Division of Chemical Sciences
Indian Institute of Science
Bangalore 560012

Tender No.: IISc/CSB/DC/2022/01

Corrigendum - 1

Subject: Revision in the content of Chemical Sciences Building (CSB) Data Centre tender (Tender No.: IISc/CSB/DC/2022/01) for the supply and installation of data centre infrastructure with server racks, cooling and management systems

Revision-2 (Page-4, Section-4, Technical Details, Point-1, Room plan)

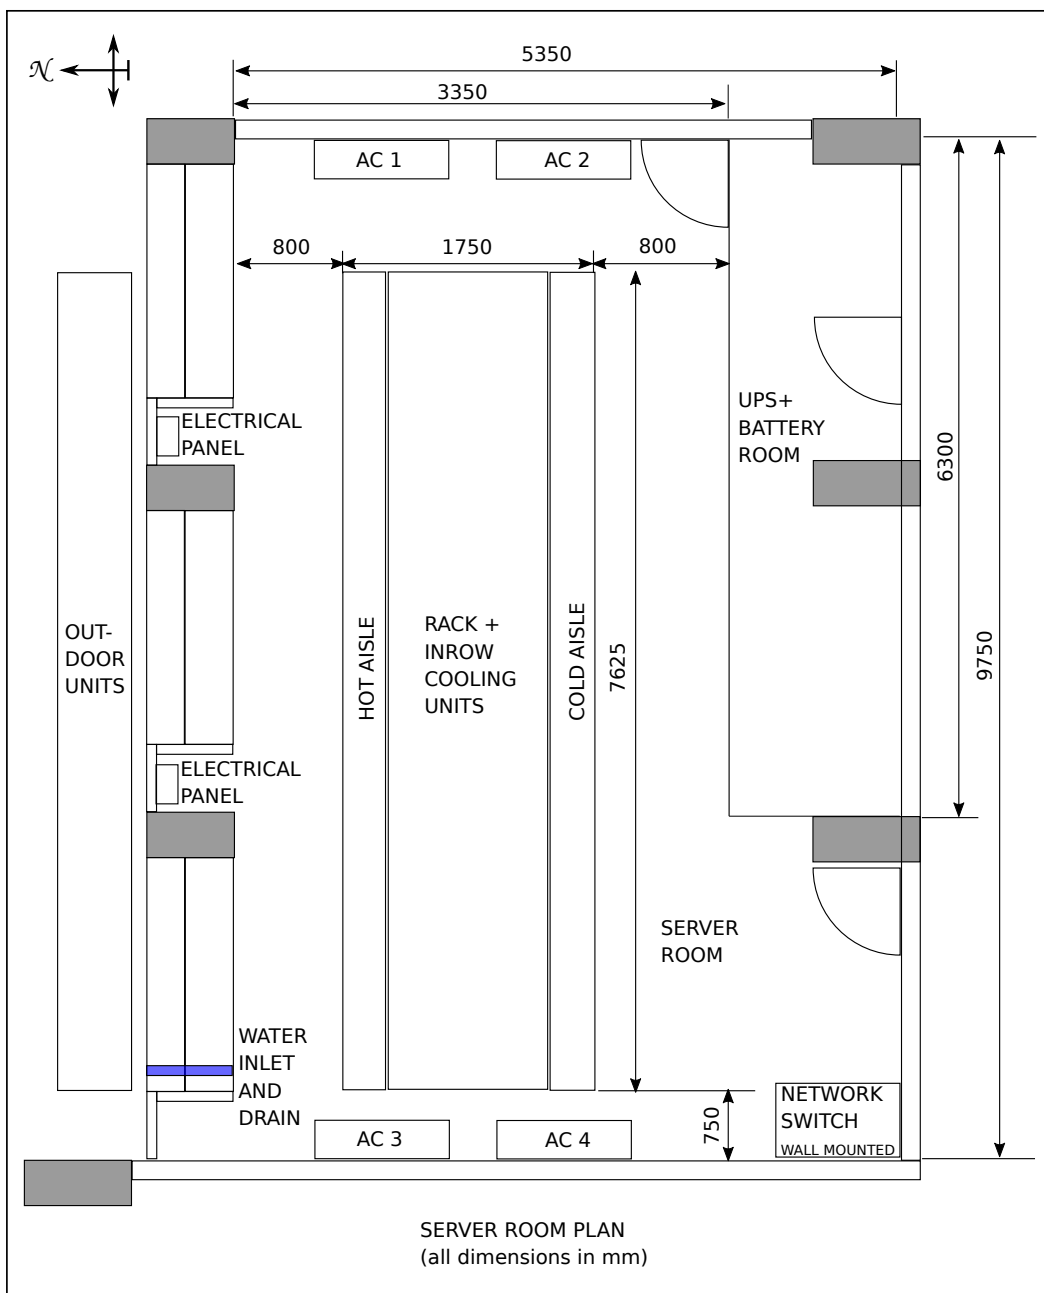
Previous Content: The row-based data center infrastructure is to be housed in a ground floor room of size (approximately) 3600 mm x 9750 mm. The area marked for the row-based cooling units (1800 mm x 7625 mm) is indicative.

Revised Content: The row-based data centre infrastructure is to be housed in a ground floor room of size (approximately) 3350 mm x 9750 mm. The area marked for the row-based cooling units (1750 mm x 7625 mm) is only indicative. You can exceed the indicated dimensions as long as comfortable movement for people is possible in the room and the computer cluster nodes can be installed/serviced without moving the server racks. The revised room plan is below. The UPS room is marked in the plan.
